Addendum

DATE: February 16, 2026
PROJECT: Harrison Township District 10
Sheriff Substation Renovation

ADDENDUM NO. 1

SHEET NO.
A1.1

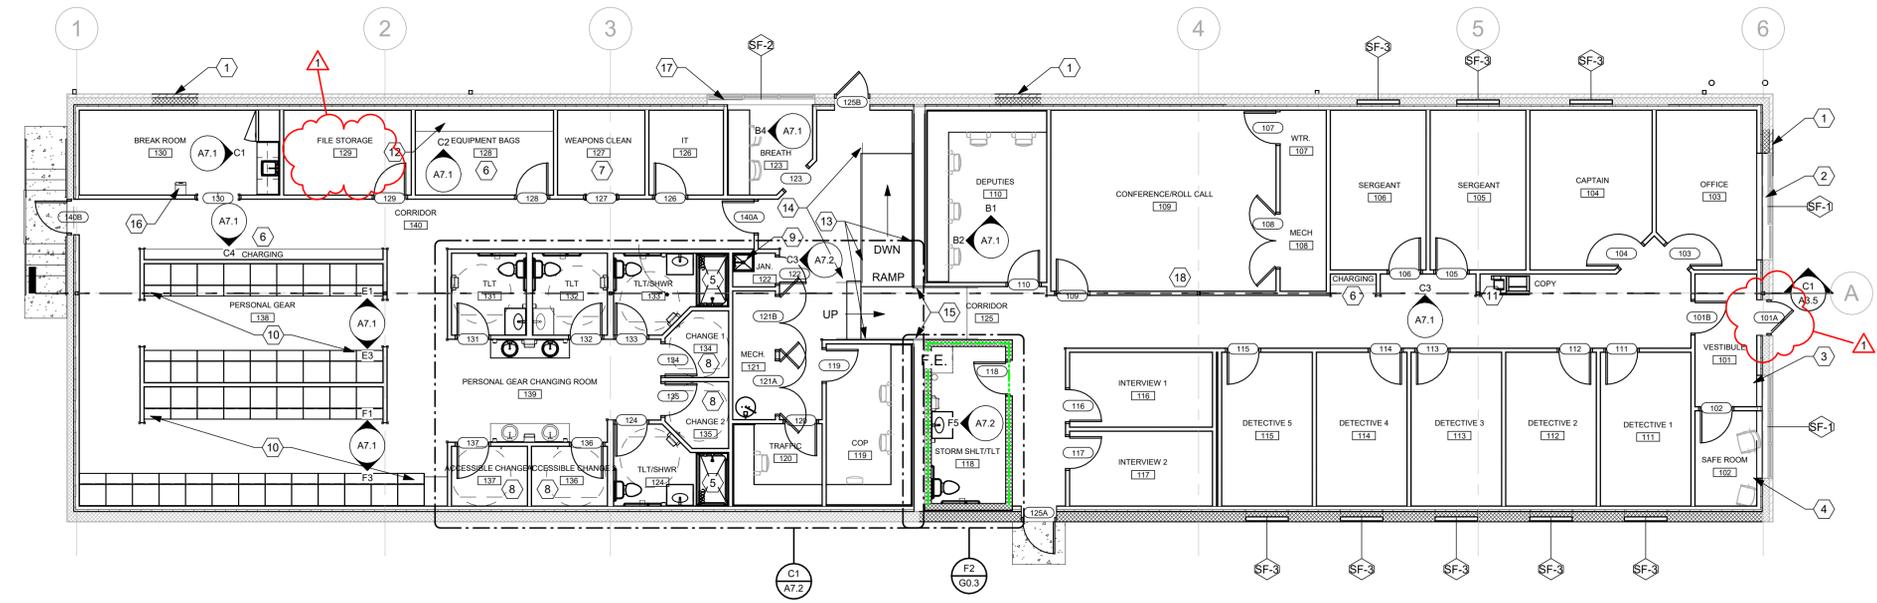
- Q10: Note 6 on A1.1 appears in Room 129, yet no shelves are shown or detailed. Please advise.
A10: Delete Note 6 in Room 129.

- Q11: Note 7 on A1.1 calls out a secure firearm rack, referring you to the interior elevations. No rack is shown or detailed. Please advise.
- A11: Provide 1 – Tiffin Firearms Rack by Steele Solutions (800-537-0983). Size: 42”W X 16”D X 45”H.

- Q17: Note 4 on A1.1 calls out an emergency lock & 911 call box for the safe room. I can't find any more info on these, are we to provide?
- A17: To be clarified in Addendum 01.

SHEET NO.
A3.2

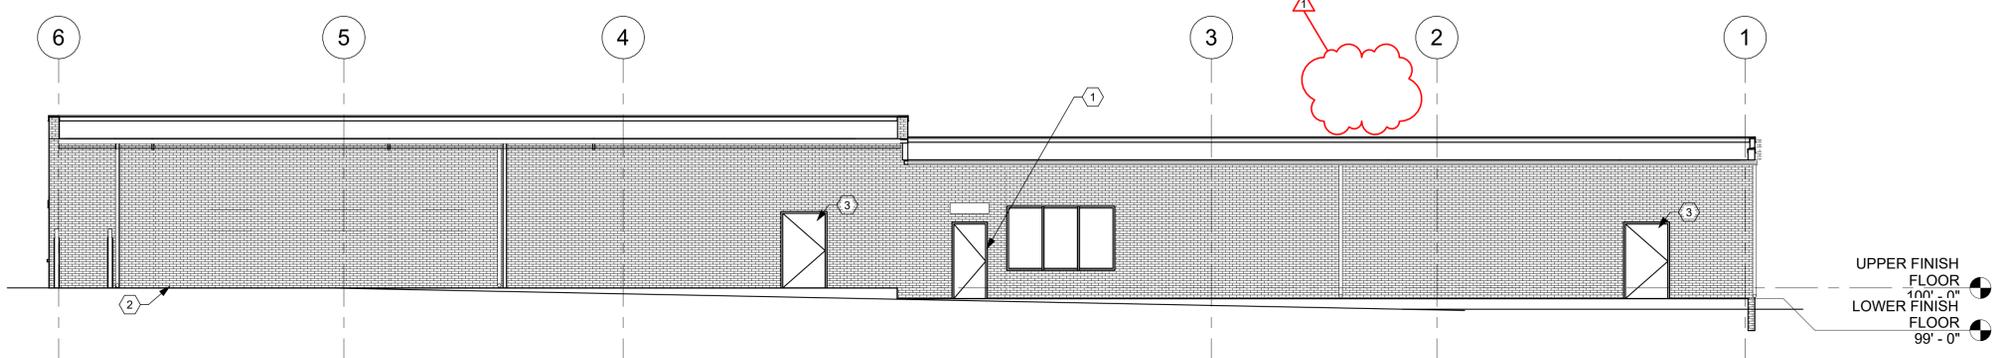
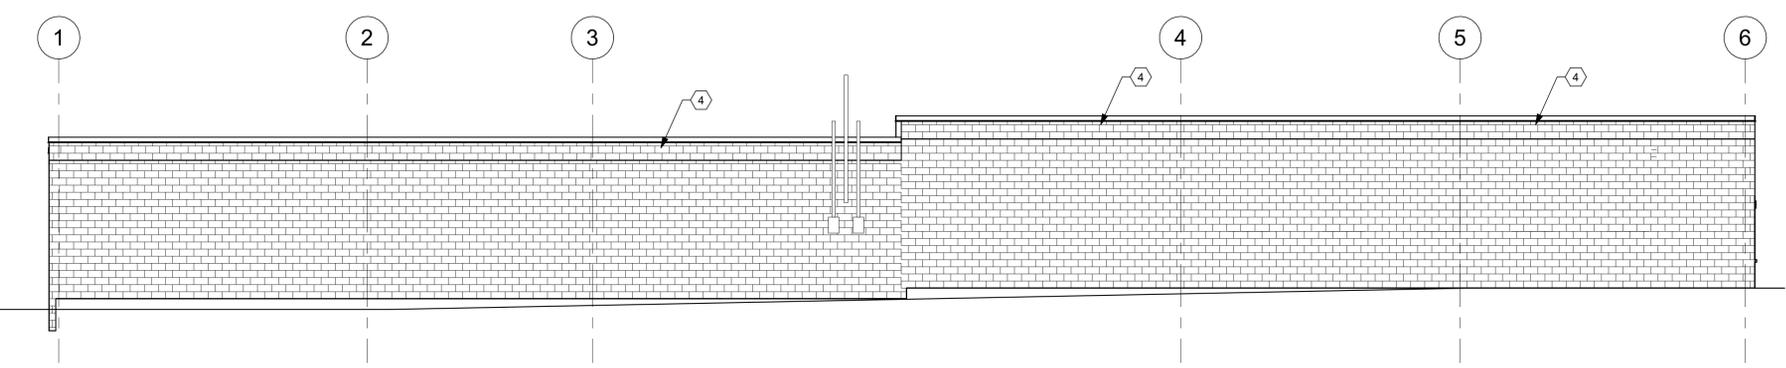
- Q1: Will utility consumption costs during construction be paid for by the Owner?
A1: Yes.
- Q2: Notes 1 and 4, Sheet A3.2 – Note 1 calls for the entire North wall to be tuckpointed, but Note 4 provides an allowance of 200 sf. Please clarify which we should include.
A2: West Elevation complete tuckpoint and repaint. South Elevation, Construction Note 4 applies. No tuckpointing on North side. Field verify all conditions.

- ⓪ INDICATES CONSTRUCTION NOTE.
- 1 TUCKPOINT AND REPAINT ENTIRE EXISTING WALL AFTER DOOR INSTALLATION.
 - 2 REPAIR EXISTING FOUNDATION TO MATCH EXISTING EXTERIOR WALL TYPE. REFER TO STRUCTURAL DRAWINGS.
 - 3 REMOVE EXISTING DOOR AND INFILL TO MATCH EXISTING EXTERIOR WALL TYPE.
 - 4 TUCKPOINT EXISTING WALL. PROVIDE ALLOWANCE FOR 200 SF. REPAINT ENTIRE WALL.

DATE	01/22/2026
JOB NO.	4325.00
DRAWN	SEP
CHECKED	RFW
COPYRIGHT © 2026 - App Architecture, Inc.	
TITLE	INTERIOR ELEVATIONS
SHEET NO.	A7.2

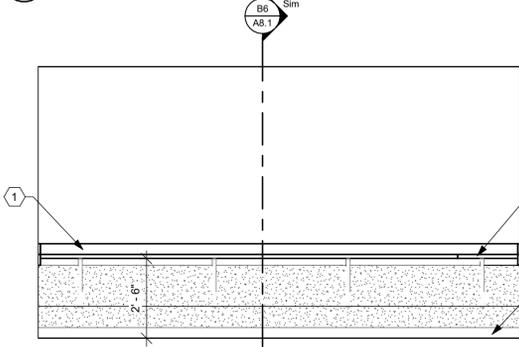
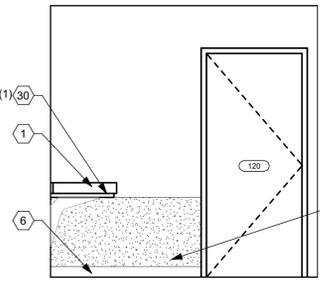
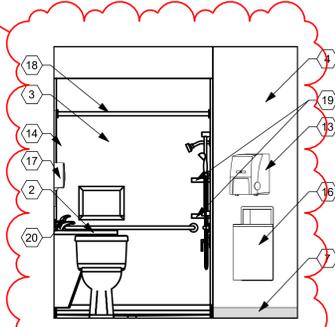
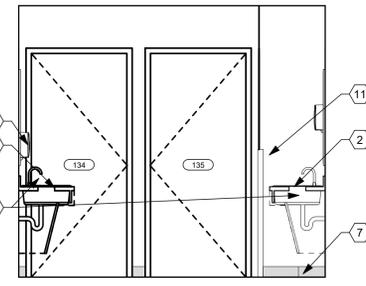
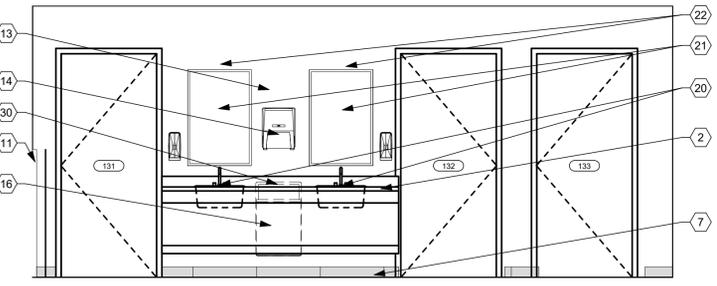
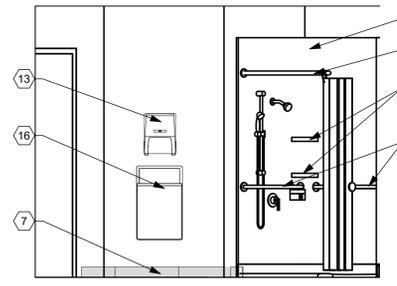
- Q23: The elevations at RR's on Sheet A7.2 contradict the room finish schedule. Room finish schedule and finish plans both show wall tile at only two wet walls for RR's. However, elevations show tile at more than two walls in the restrooms. Confirm which should be followed.

- A23: Tile on highlighted walls to run full height. See Drawing Sheet A7.2 attached.
- Q24: Where is the overhead service drop, meter and CT cabinet going to be located? Some thought needs to be put into how far you can run inside the building with un-fused conductors, since the two panels are located in the middle of the building. Please advise.

SHEET NO.
A9.1

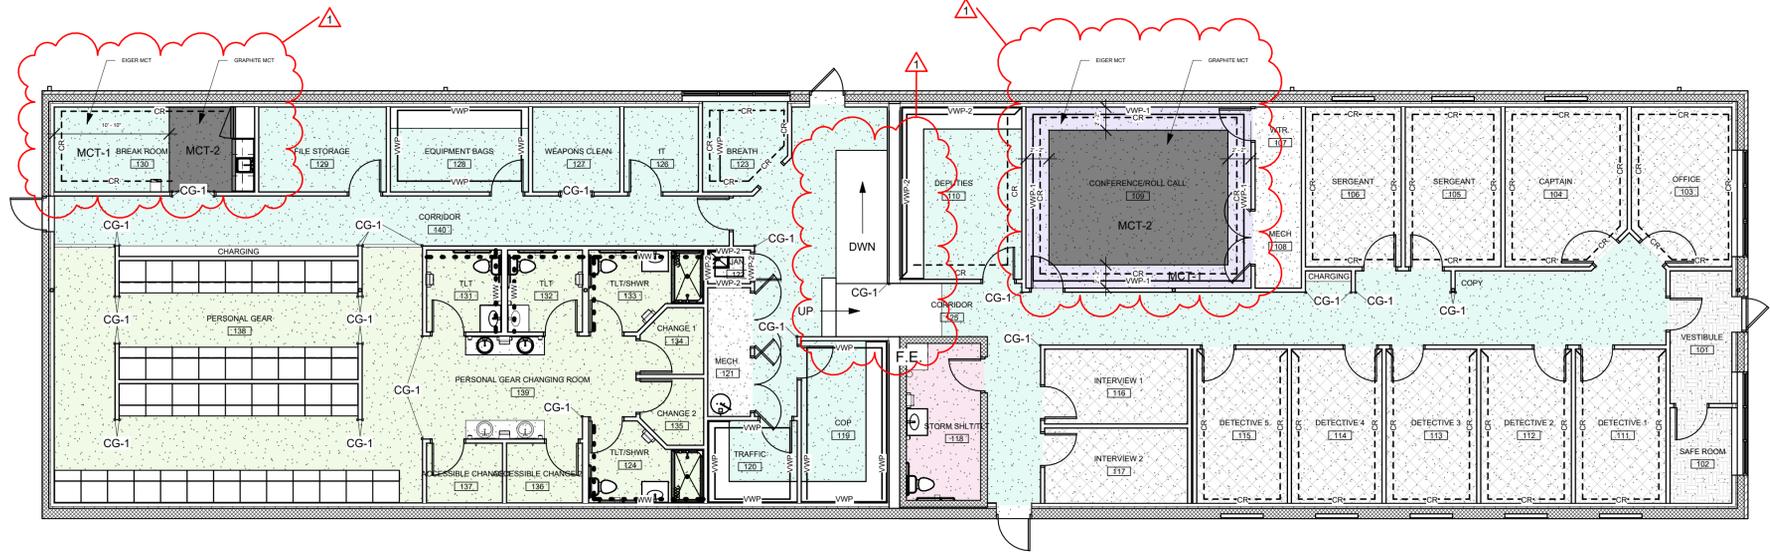
- Q22: Confirm flooring material at the ramp and step at Corridor 125.
- A22: Use MCT-1. All edges of MCT-1 to be protected with Flexco, Lap Type Square Stair Nosing along outer edges of Ramp. Nosing to be used at stair edges. See revised Drawing Sheet A9.1 attached.

- A. REPAIR, LEVEL, AND PREPARE EXISTING CONCRETE FLOOR SLABS TO RECEIVE NEW FLOOR FINISH. REFER TO ARCHITECTURAL ROOM FINISH SCHEDULE AND SPECIFICATIONS FOR ADDITIONAL INFORMATION.
- B. USE MCT-1, EIGER FOR RAMP AND STAIR AT LEVEL CHANGE BETWEEN CORRIDORS 125 AND 140. ALL EDGES OF MCT-1 TO BE PROTECTED WITH FLEXCO, LAP TYPE SQUARE STAIR NOSING ALONG OUTER EDGES OF RAMP. NOSING TO BE USED AT STAIR EDGES.

SHEET NO.
S1.0

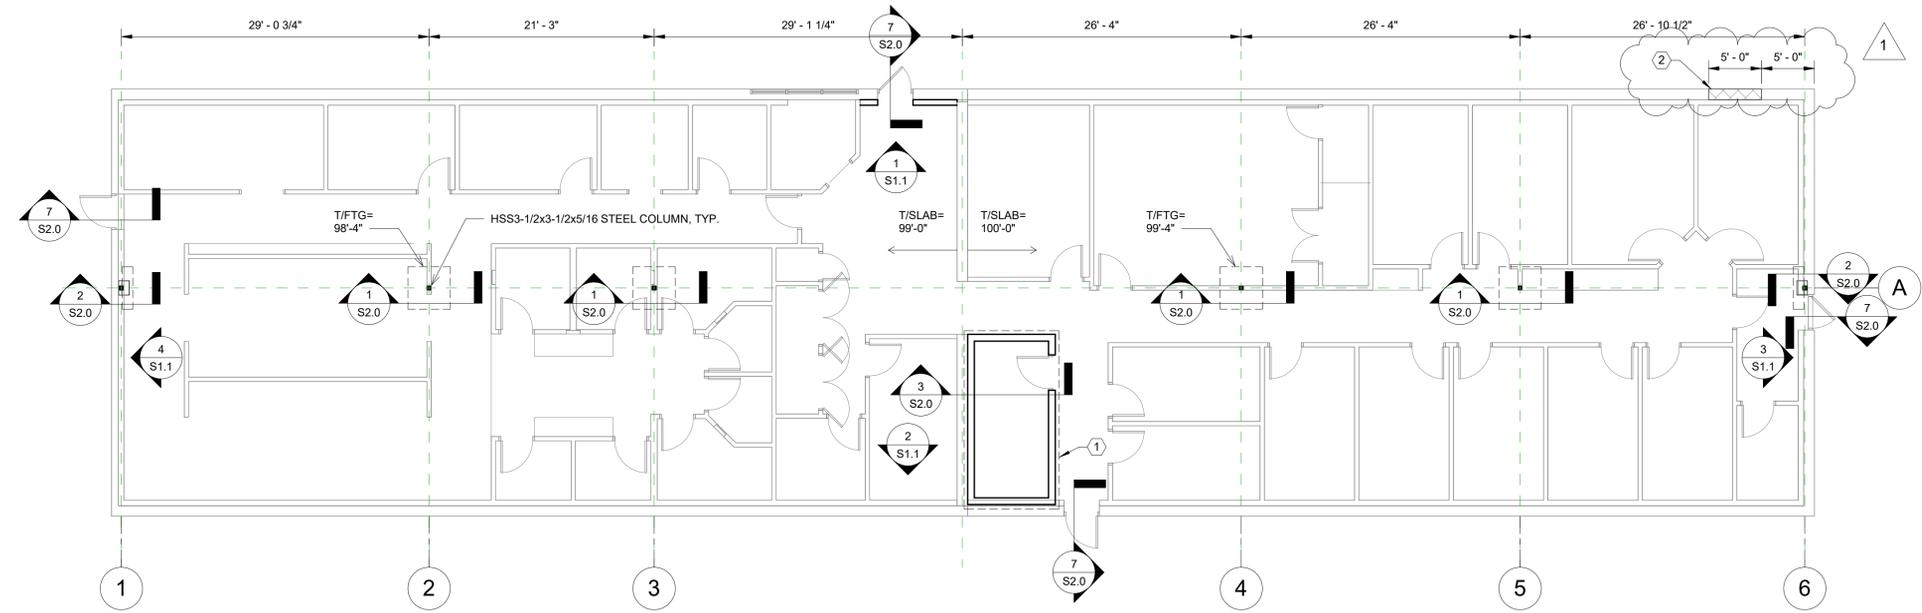
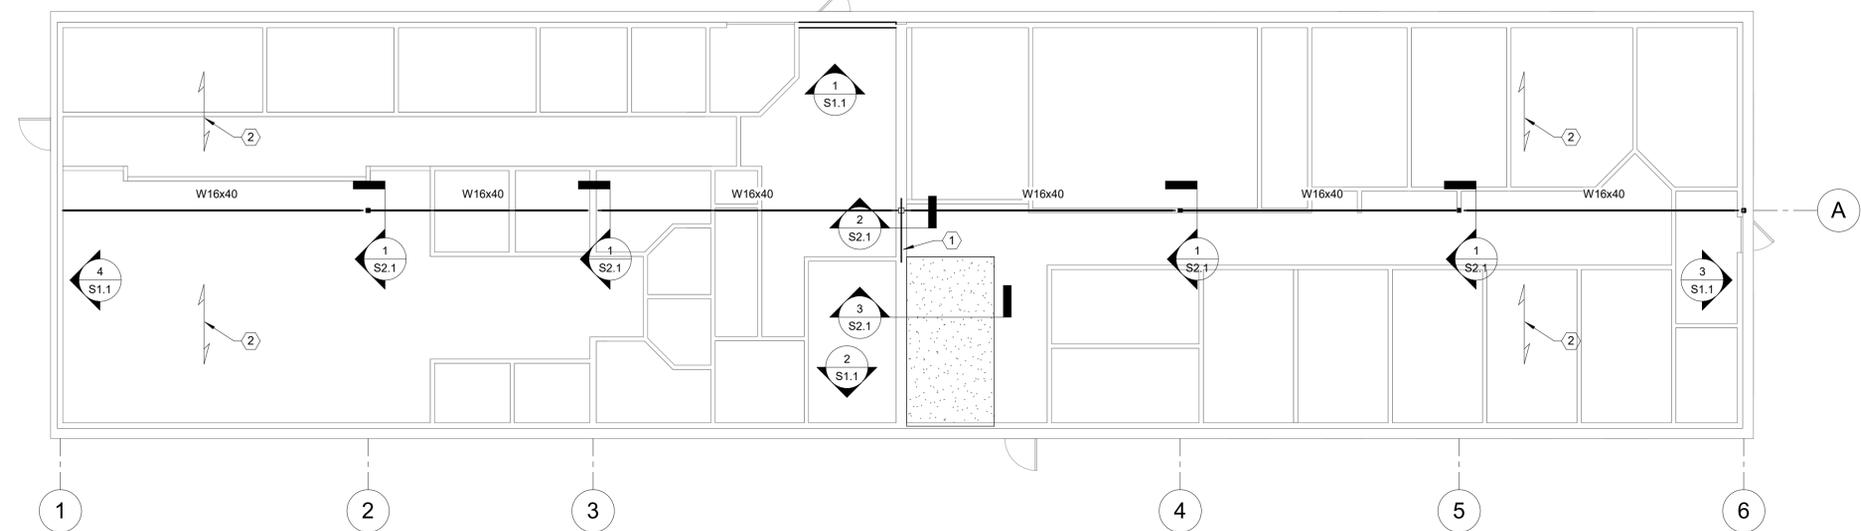
- Q18: Dimension Plan A1.2, note 3, and sheet A3.2, note 2 state “Repair existing foundation to match existing exterior wall type, refer to structural drawings.” These show up at the NE corner of the bldg. where the gas meter is. Nowhere in the S drawings is this work mentioned or detailed. What is the extent of scope here?

- A18: See Drawing Sheet S1.0 attached.
- Q19: Is there any way we can find out what existing key system they are using on this/who manages that key system so I can accurately quote the cores and keys?

- PROVIDE AN 8" THICKENED SLAB w/ #4 BARS AT 12" O.C. EACH WAY.
- HATCHED AREA DENOTES APPROXIMATE SECTION OF EXISTING STEM WALL WITH BROKEN CMU. EXCAVATE TO THE FOOTING AND REPLACE ALL DAMAGED BLOCKS [GROUT SOLID].
